STAFF RECOMMENDATION 2108 11th Avenue South October 16, 2019

Application: New Construction—Addition and Outbuilding
District: Waverly-Belmont Neighborhood Conservation Zoning Overlay
Council District: 07
Base Zoning: R8
Map and Parcel Number: 10513017000
Applicant: Brad Van Rassel
Project Lead: Sean Alexander, sean.alexander@nashville.gov

<p>Description of Project: An application to construct a ridge-raise and rear addition to an historic house, and to construct a one and one-half story outbuilding.</p> <p>Recommendation Summary: Staff recommends approval of the proposed addition and outbuilding at 2108 11th Avenue South with the following conditions:</p> <ol style="list-style-type: none">1. The existing front porch steps shall not be relocated;2. The addition shall not be both taller and wider than the historic house, either by eliminating the projecting bay or the ridge-raise component of the addition; and3. Additional information on the exterior materials shall be administratively approved before a permit is issued. <p>Meeting those conditions, Staff finds that the proposal meets the design guidelines for the Waverly-Belmont Neighborhood Conservation Zoning Overlay.</p>	<p>Att

2108 11th Avenue South, front.

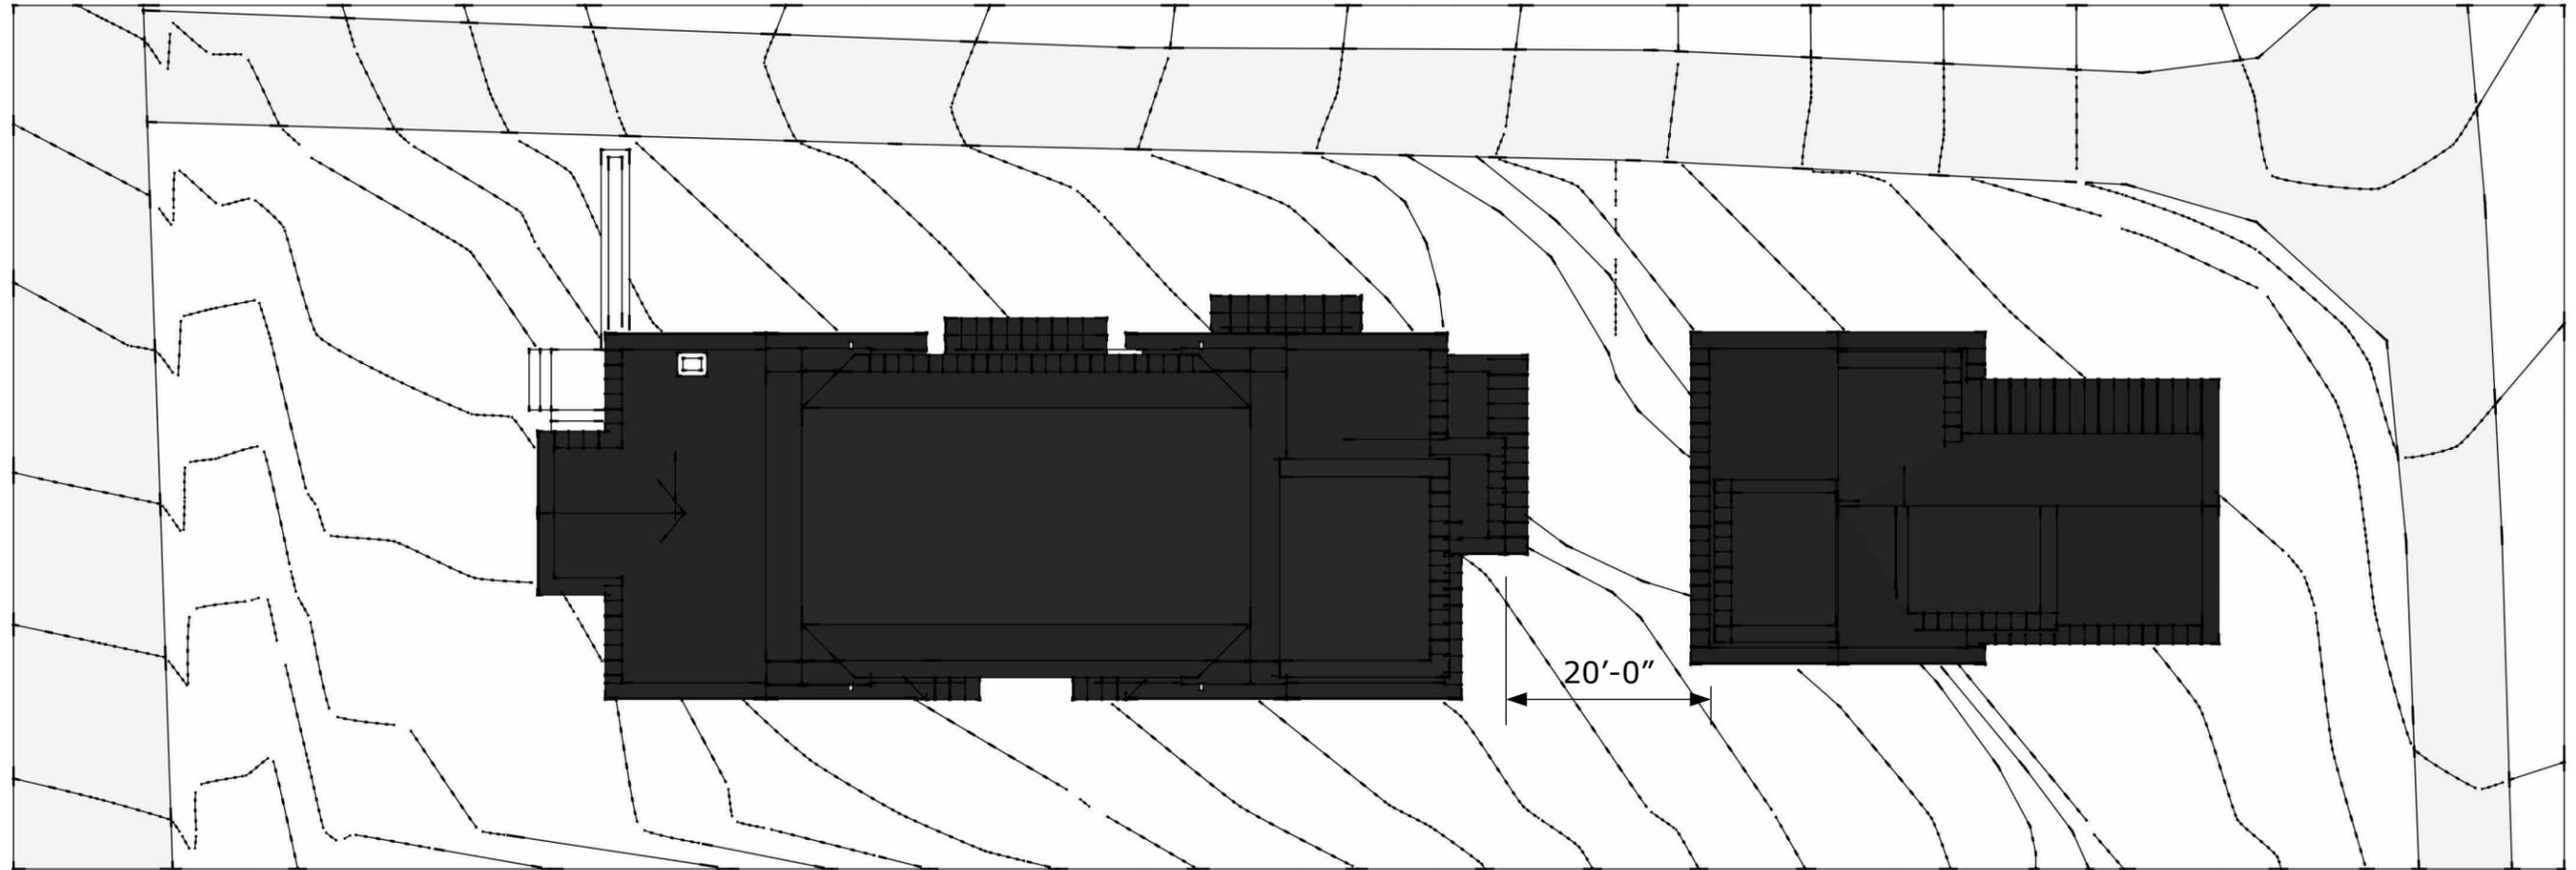
The plans also indicate that the existing front stairs leading from the front porch will be replaced and relocated on the side of the porch, rather than being oriented directly toward the street. These stairs appear to be original and contribute to the original orientation of the house toward the street. Staff finds that their relocation is not appropriate.

The shutters, metal porch posts, and railing will be removed. The shutters may be an original feature but their removal is not an action reviewed by the Commission. The railing and posts are not likely to be original to this building therefore their replacement is appropriate. The replacements will be simple square posts. Staff recommends a cap and base be added to the posts. A replacement railing is not indicated.

The tails on the front porch and primary roof rafters would likely have been exposed originally, but have since been enclosed and had gutters added. The proposal indicates that the rafters will be returned to their original appearance, but the original roof pitch will not change.

Orientation: As described in the “Partial Demolition” section above, the plans indicate that the steps leading from the front of the original front porch will be removed and replaced with steps leading to the left. This inappropriately alters the orientation of the primary entrance of the house and does not meet section III.F of the design guidelines for new construction-orientation.

1. The existing front porch steps shall not be relocated;
2. The addition shall not be both taller and wider than the historic house, either by eliminating the projecting bay or the ridge-raise component of the addition; and
3. Additional information on the exterior materials shall be administratively approved before a permit is issued.

2108 11th Avenue South, left side.

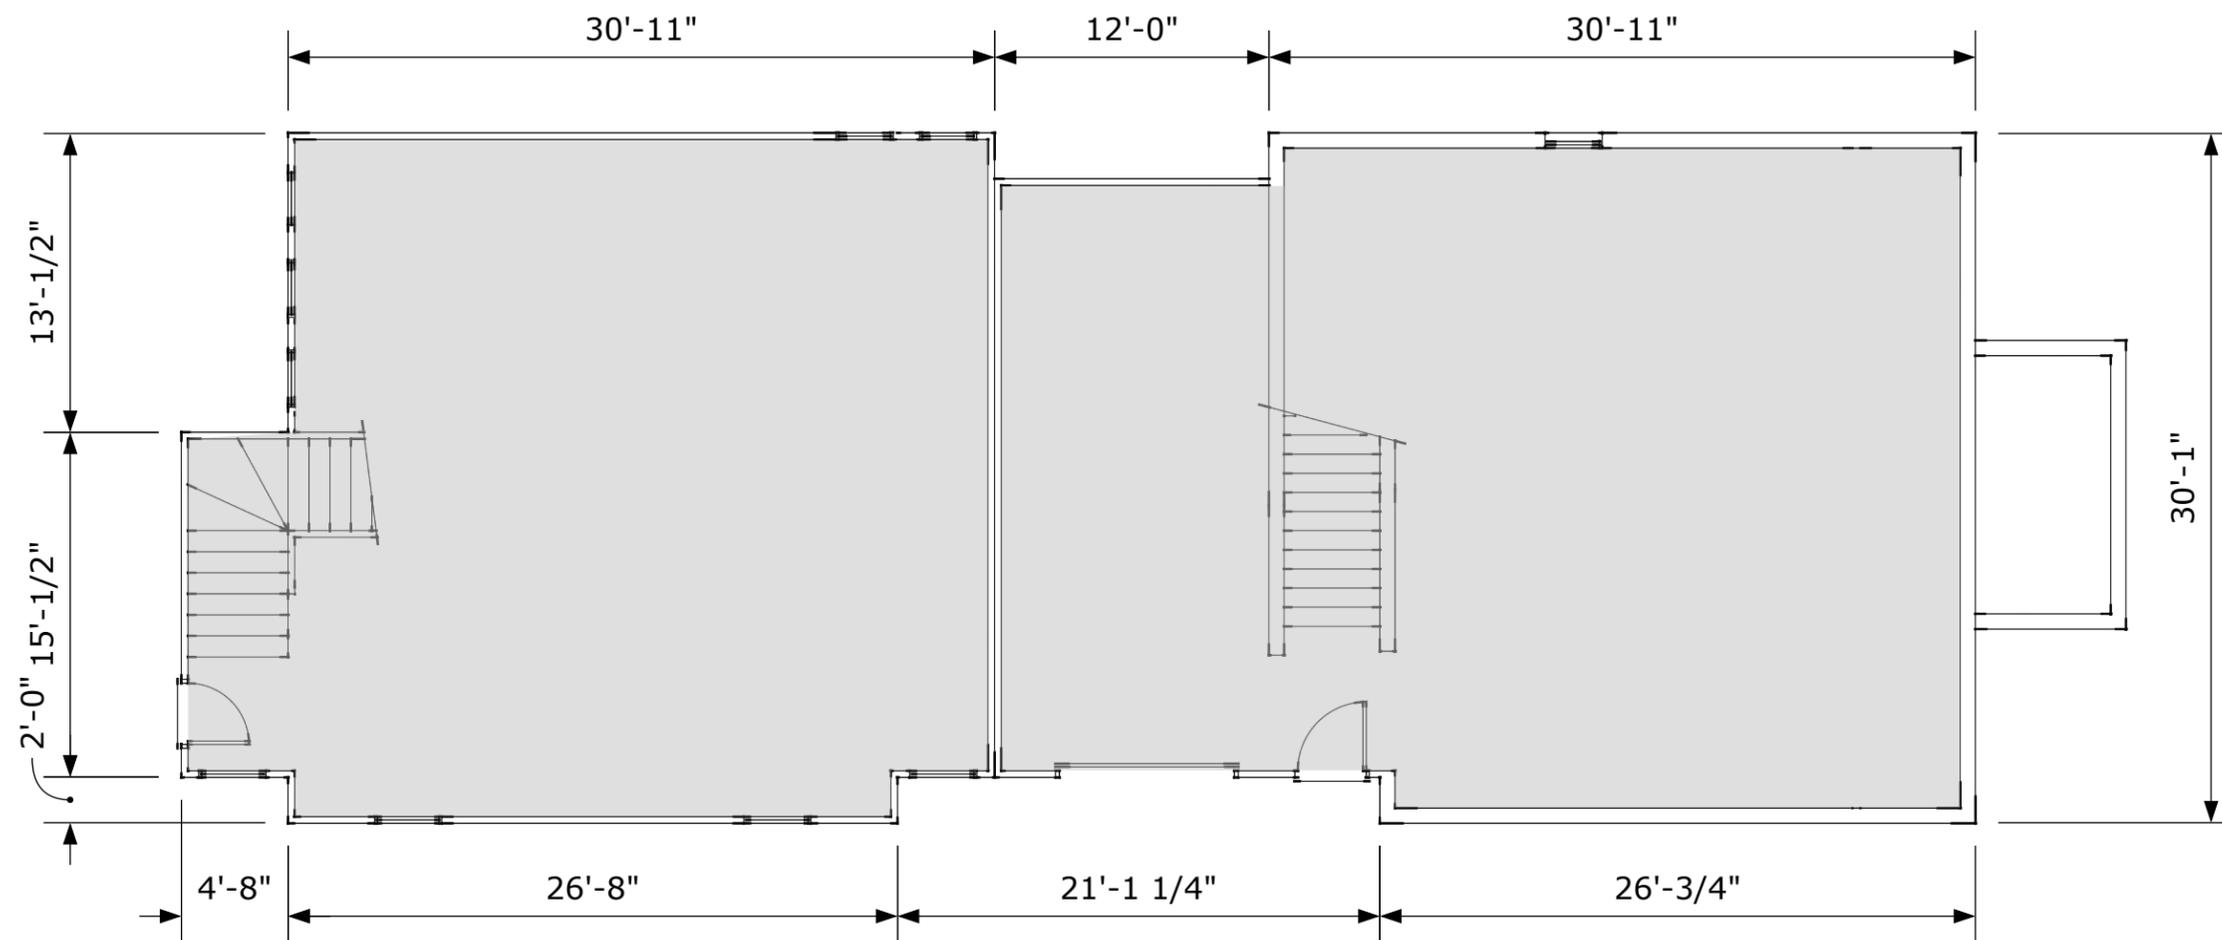
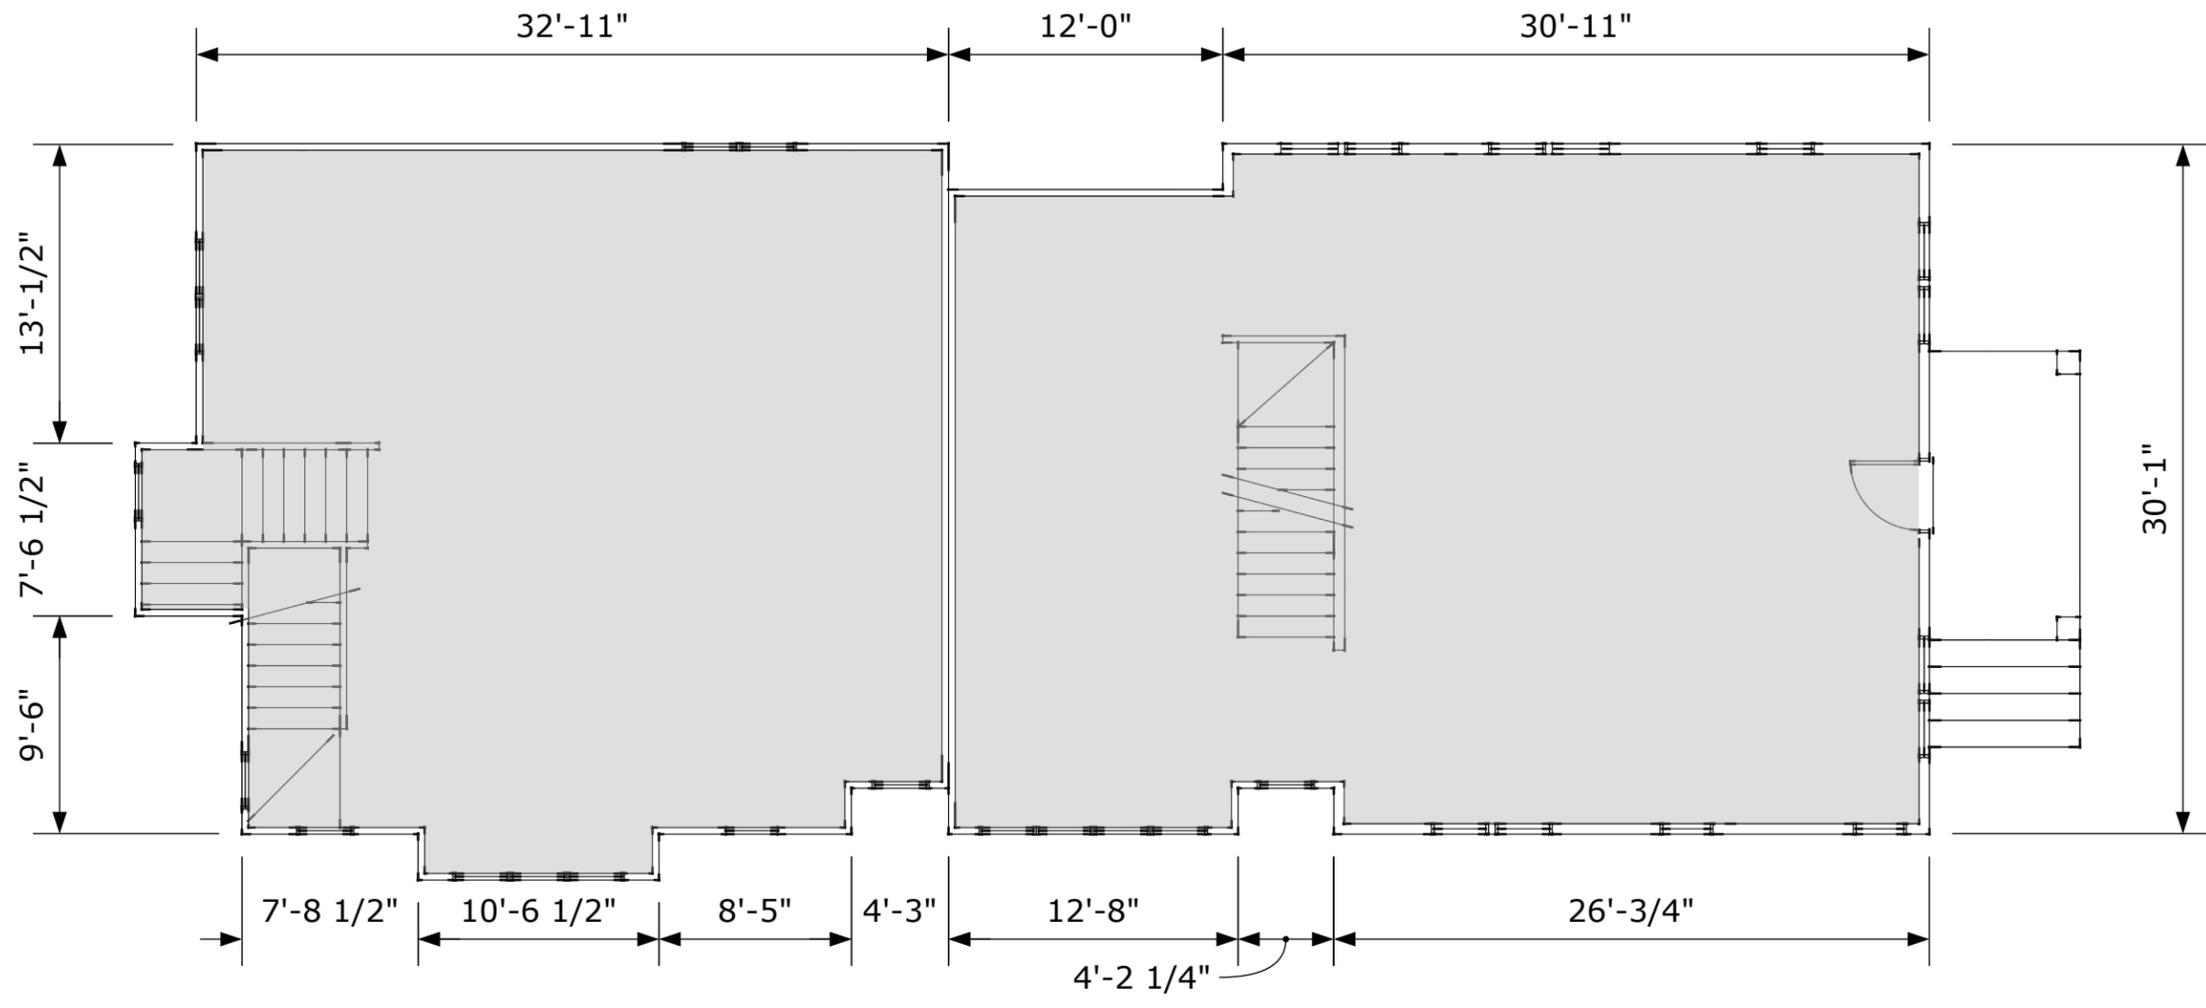
The plans indicate that three windows will be installed on the left side of the house, within the basement or foundation wall. Staff finds this to be appropriate as new side-windows at the foundation level will not greatly alter the historic look of the building.

The proposal also includes a one-story bay projecting two feet (2') wider than the historic house on the left side of the addition's primary mass. While a bay of this size itself would not be inappropriate, because the project includes a ridge-raise this would make the addition both taller and wider than the historic house. The Commission has generally not approved additions to be taller and wider than an historic house. In addition, the house gains usable space due to a drop in grade and it will be highly visible because of a side alley, resulting in more space between buildings than is typical elsewhere in the district. All together the alterations proposed equate to a three-story addition on a one-story house; therefore, there isn't a case for the addition to also be wider than the historic building.

Proportion and Rhythm of Openings: As described in the “Partial Demolition” section above, the plans indicate that three windows will be installed on the left side of the original basement or foundation wall. The addition of these new windows will not negatively impact the historic character of the house. The windows on the addition are all generally twice as tall as they are wide, with no large expanses of wall space without a window or door opening.

To meet this condition, the applicant may eliminate the projecting bay or the ridge-raise component of the addition.

2108 11th Avenue South, rear.

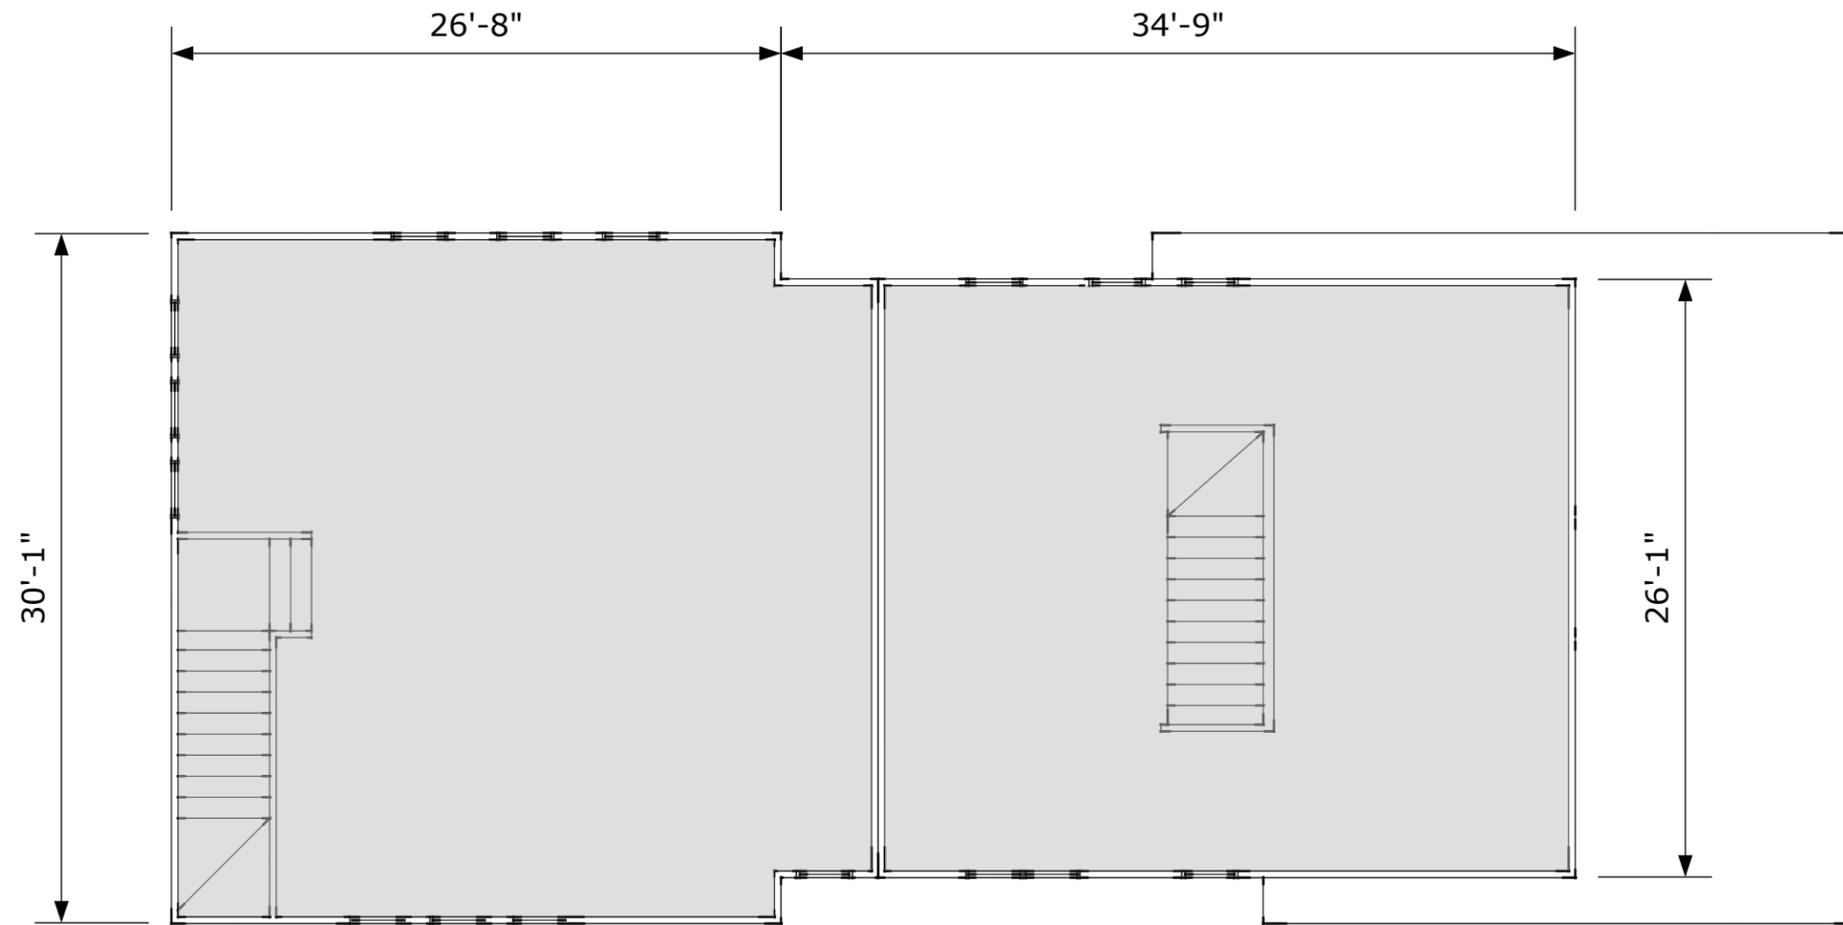
Demolition: The application involves demolishing portions of the rear wall and rear slope of the roof to accommodate the new addition. Staff finds the partial demolition at the rear of the building to be appropriate as the rear of the building is not visible from the street and not a character defining feature.
